Whitworth Street Planning Comparison

Since planning approval in 2016 the site has been purchased by Vision Manchester Limited. The client has engaged a full design team and RussellWBHO to update the detail design to the required regulations, agree a building contract and construct the development. Through this process a number of design changes are being proposed.

This updated document is being presented to Manchester City Council Planning Department to illustrate and explain the nature and extent of the proposed changes and to seek the Council's formal approval through the necessary planning process.

3.10 Proposed 19th Floor Plan

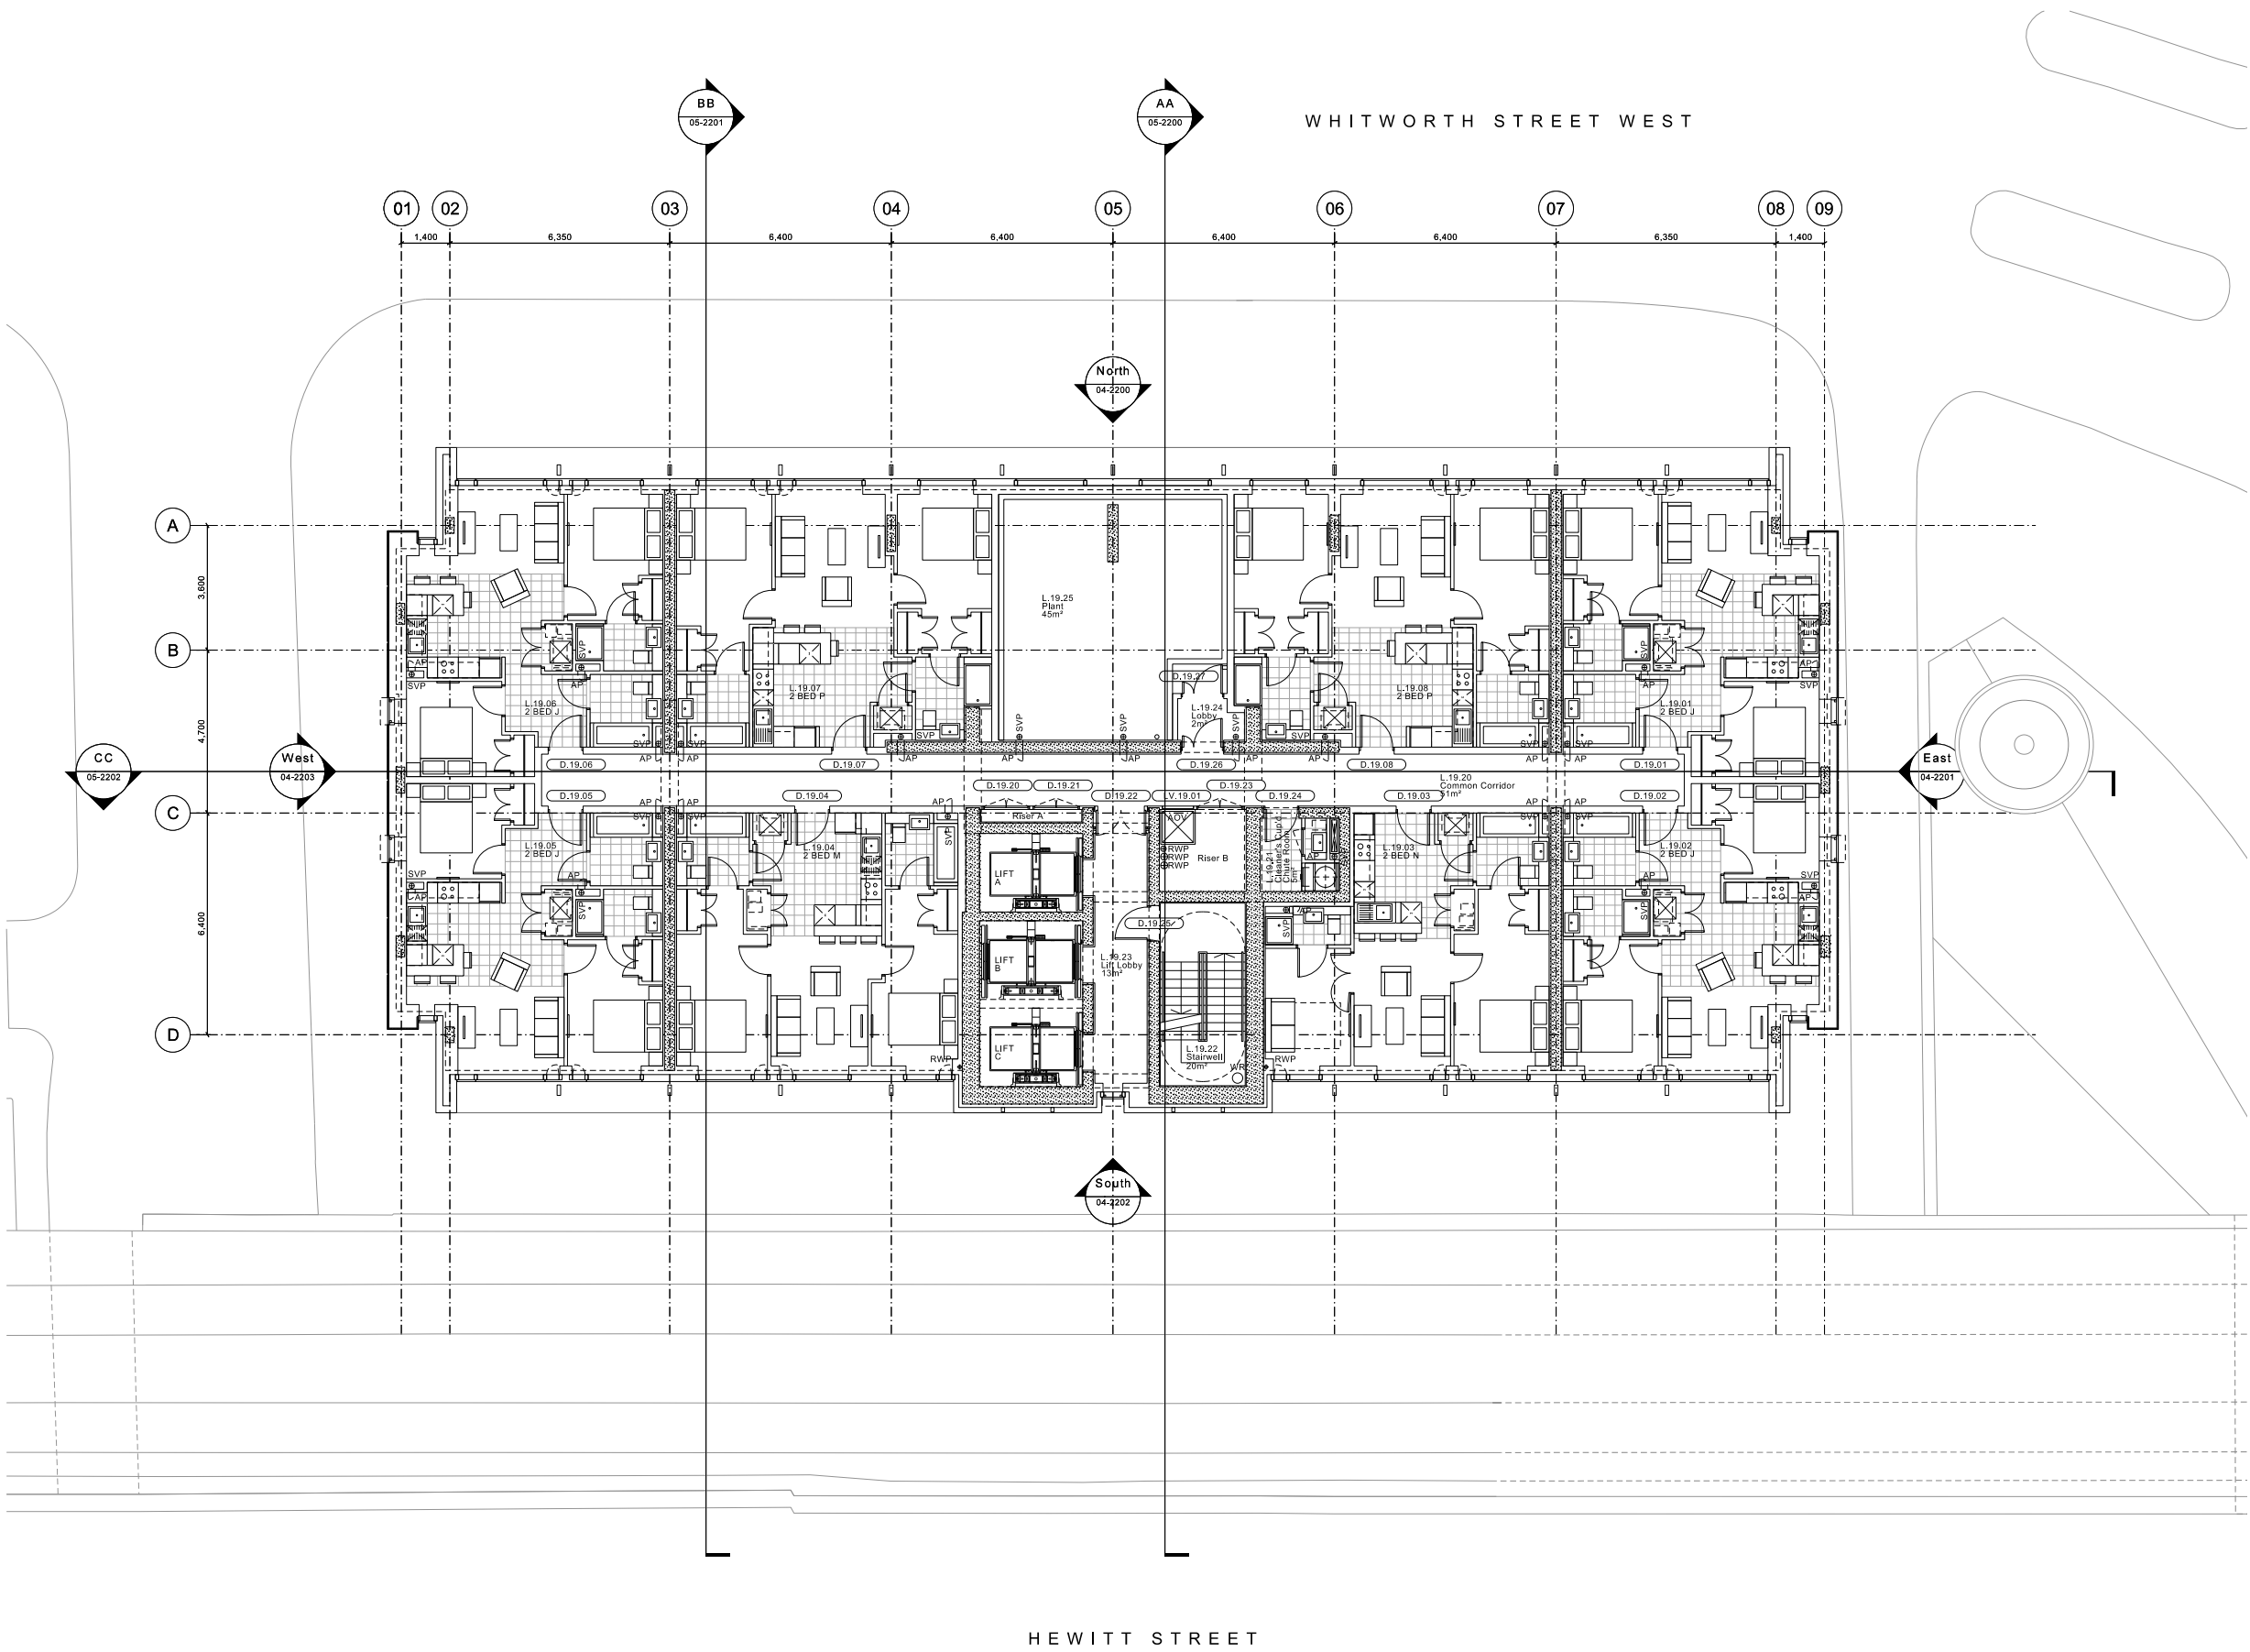
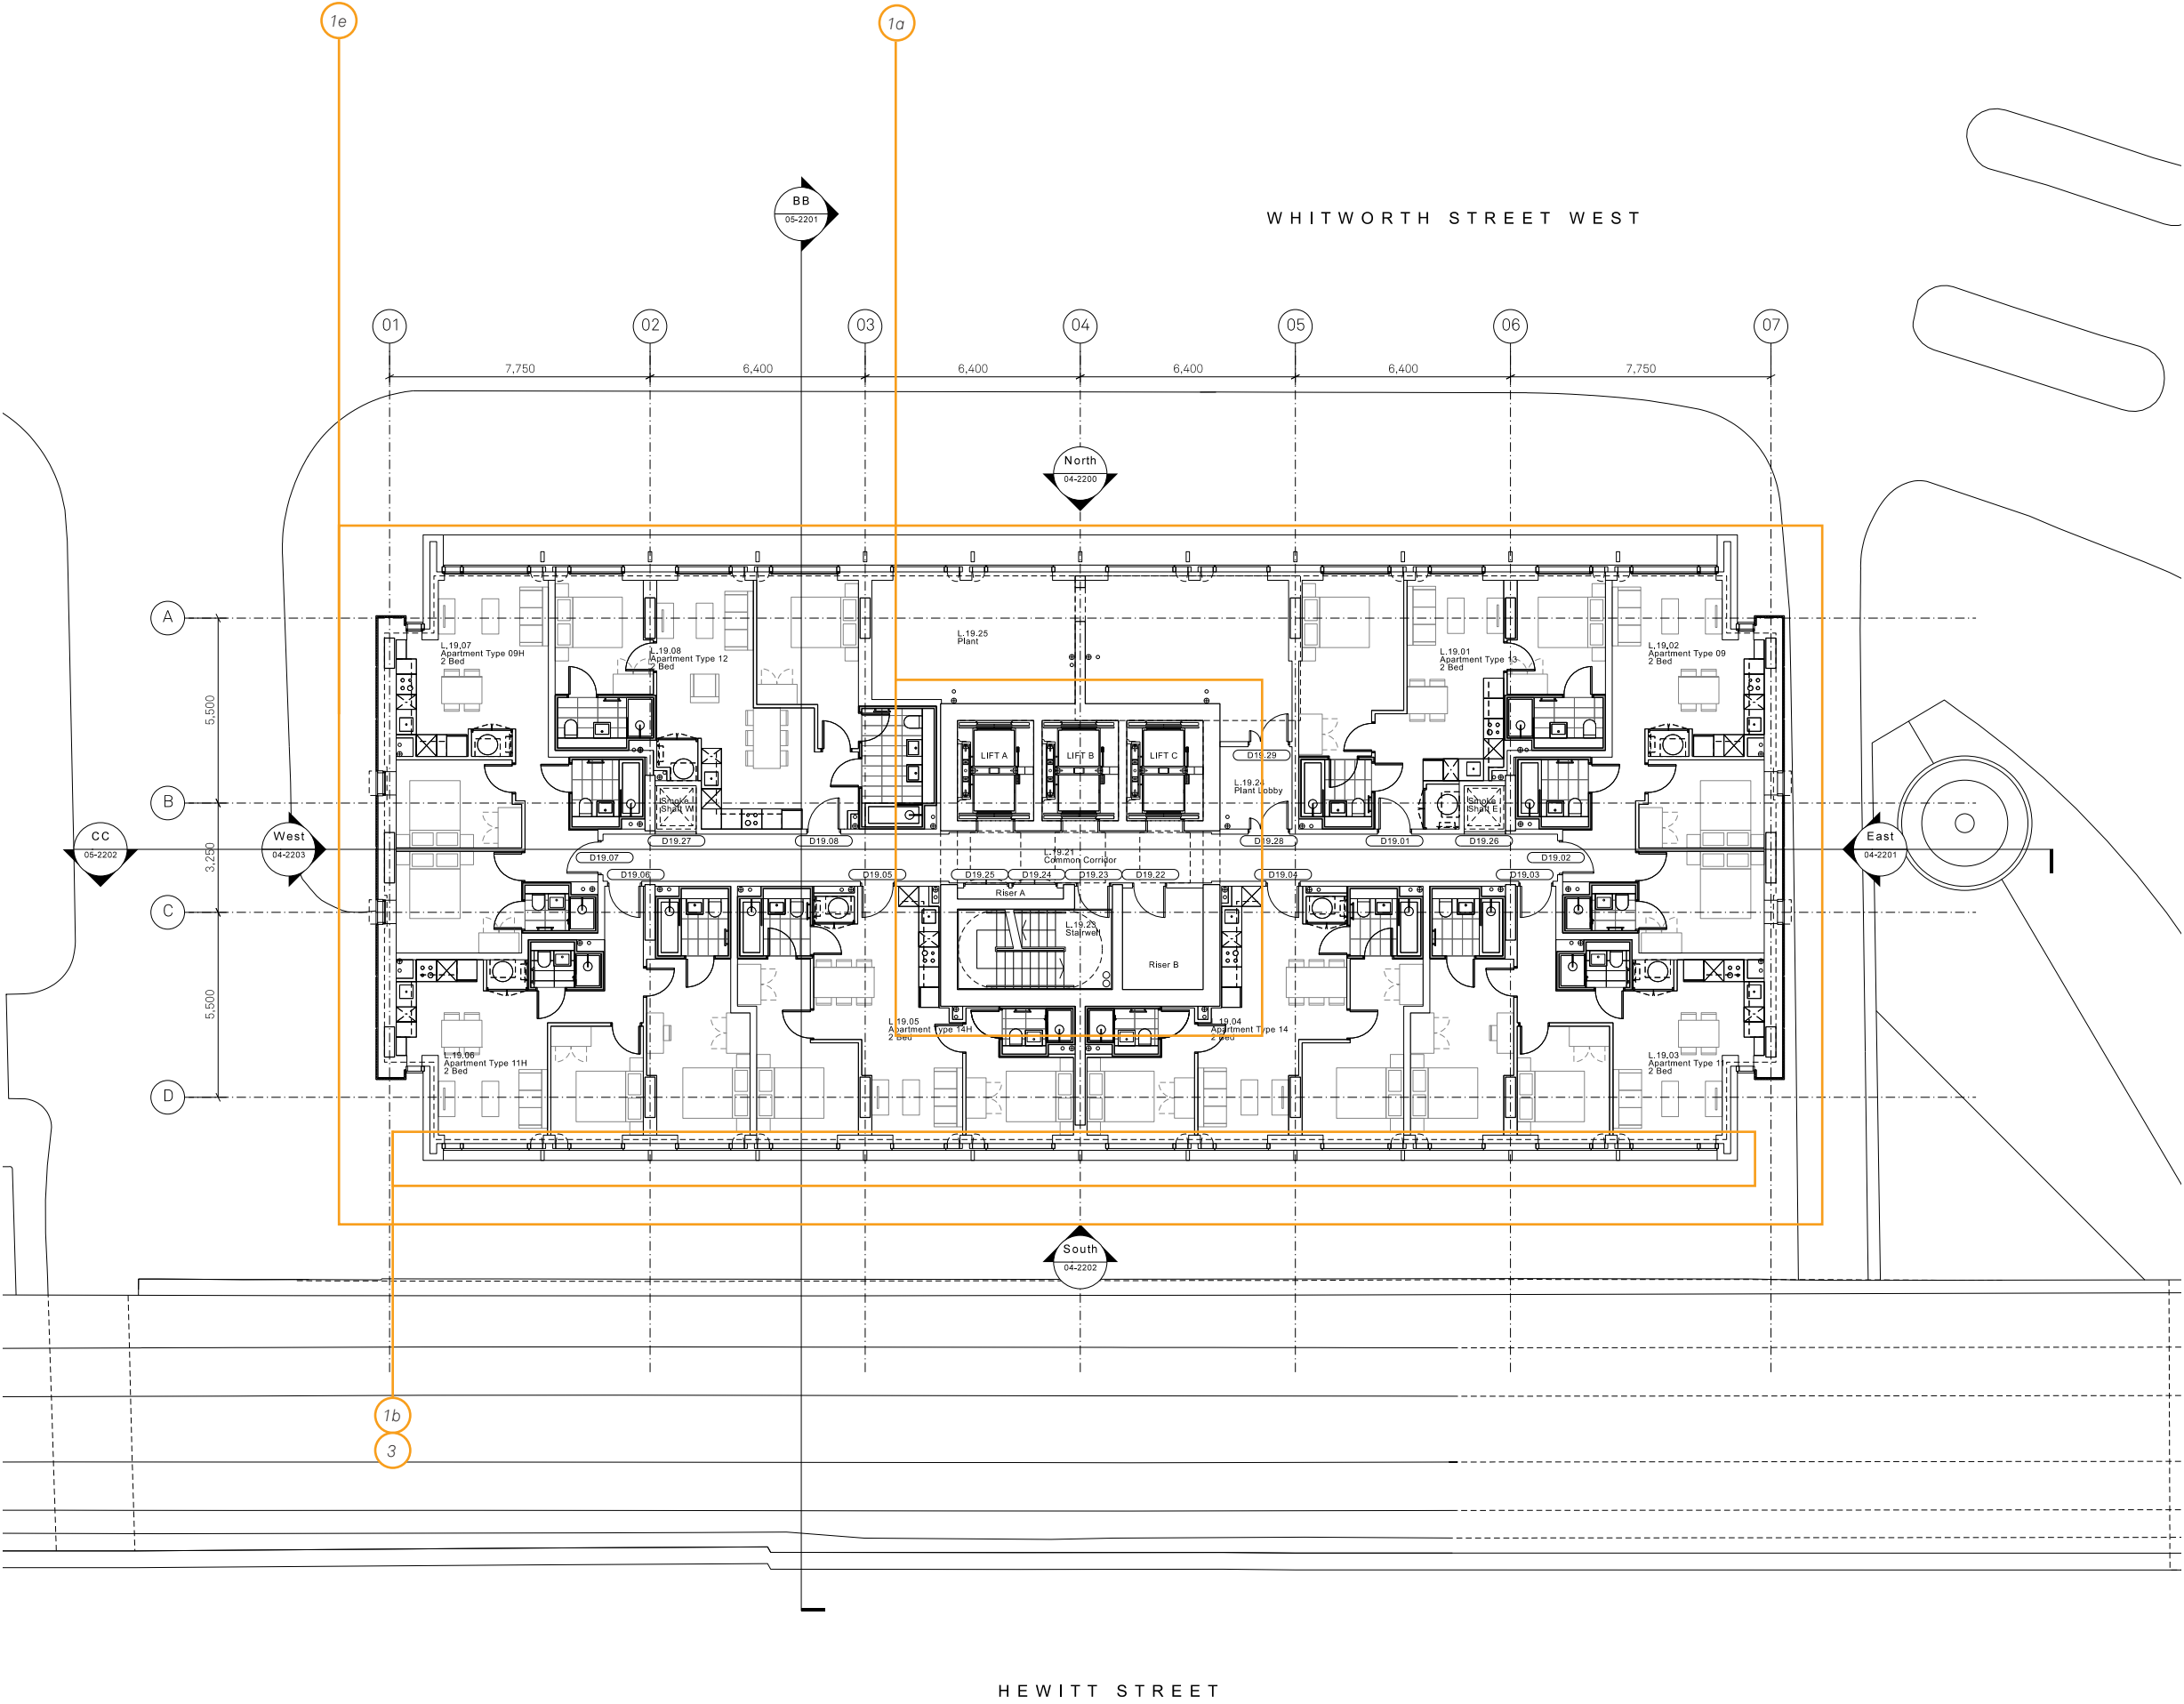
- 1a - Core Repositioned
- 1b - Main body of south facade to match north facade
- 1c - Entrance relocation
- 1d - Form of roof pavilion
- 1e - Apartment & amenity layouts
- 1f - Inclusion of commercial unit & dedicated entrance
- 2a - Reduced floor to floor heights
- 2b - Additional floor
- 2c - 2 no. Guest Beds & 2 no. 1 Bed become 2 no. 2 Bed & 2 no. 3 Bed
- 3 - South 'picture frame' reveal depth reduced by 600mm
